Annex 83A – Task Force Discussion New Orleans, LA - Jan 2009

83A - comment resolution priority

83A – Layer diagram

Chip to module

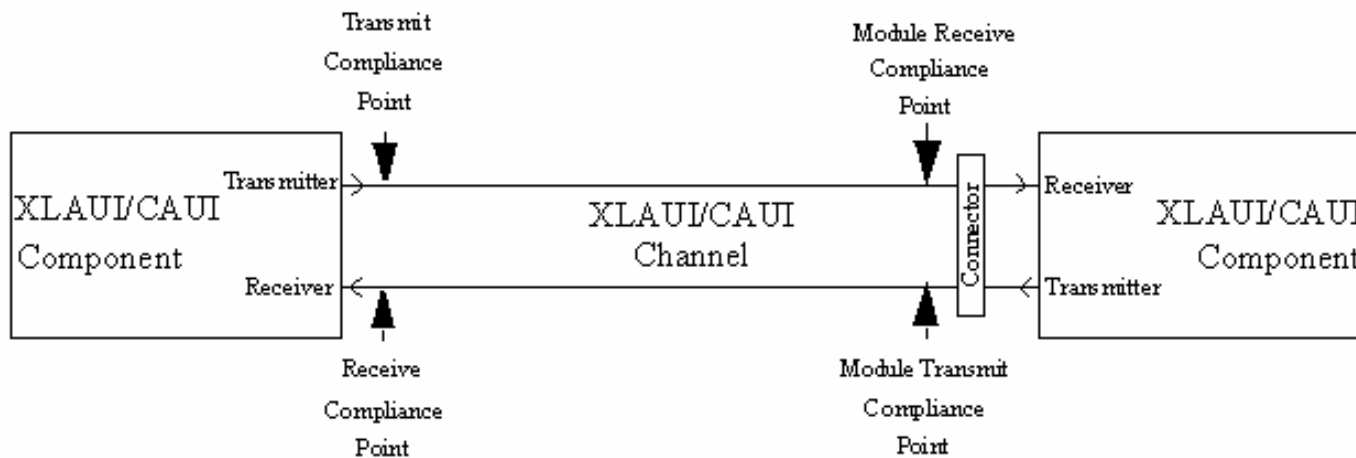
Proposal: Add figure with explicit connector and **module compliance** points and associated loss budget

Comments:295,662,661,617

Section	Loss Budget
Host XLAUI / CAUI Component to Module Compliance Point	7.9dB
Connector Loss	0.5dB
Connector to Module XLAUI / CAUI Component	2.1dB

Summary: Loss budget identical, compliance point definition is the difference

Add new annex or subclause to 83A

- **XX.X Chip to module**
 - Text for compliance points and partitioning of channel budget
 - Add crosstalk limits
- **XX.X Module transmitter characteristics**
 - Updated table & return loss
- **XX.X Module receiver characteristics**
 - Updated table & return loss
- **NOTE: needs completion this week to produce a technically complete draft with no open technical issues**

SDD21

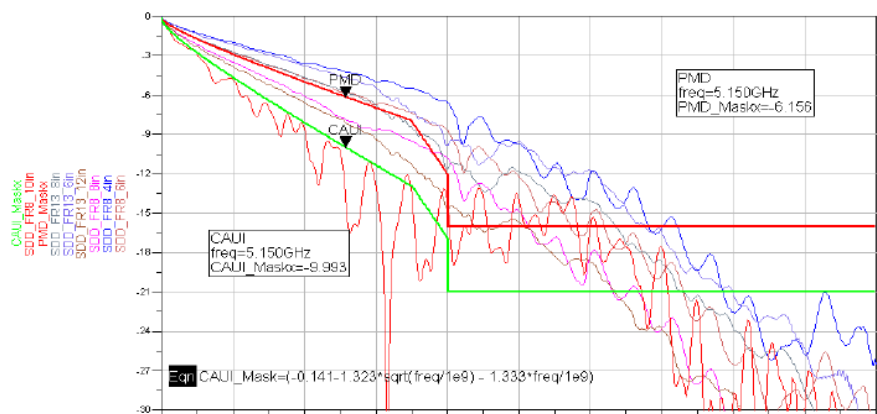
Data shown up to 20 GHz but the mask should stop at 11.1 GHz

Comments:260,59,262,60

Summary:
SDD21 in agreement, increase to 10.5 dB at 5.5GHz

SDD11

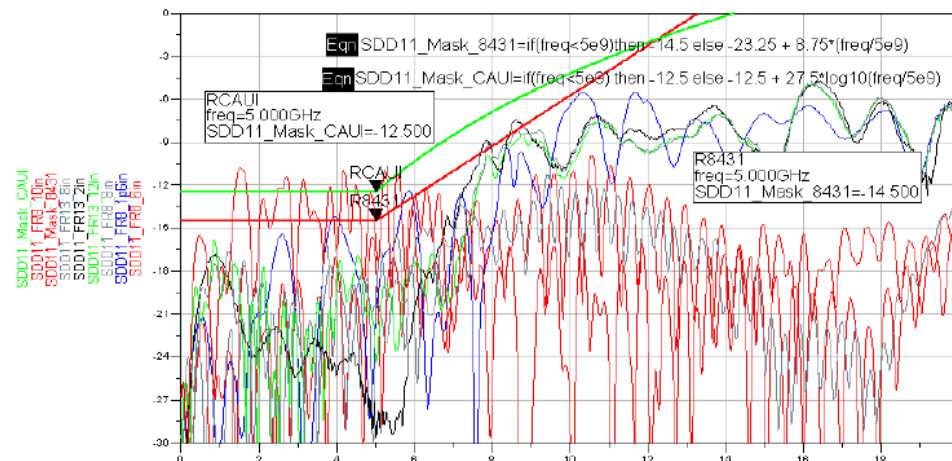
Data shown up to 20 GHz but the mask should stop at 11.1 GHz freq, GHz

SDD11 in agreement
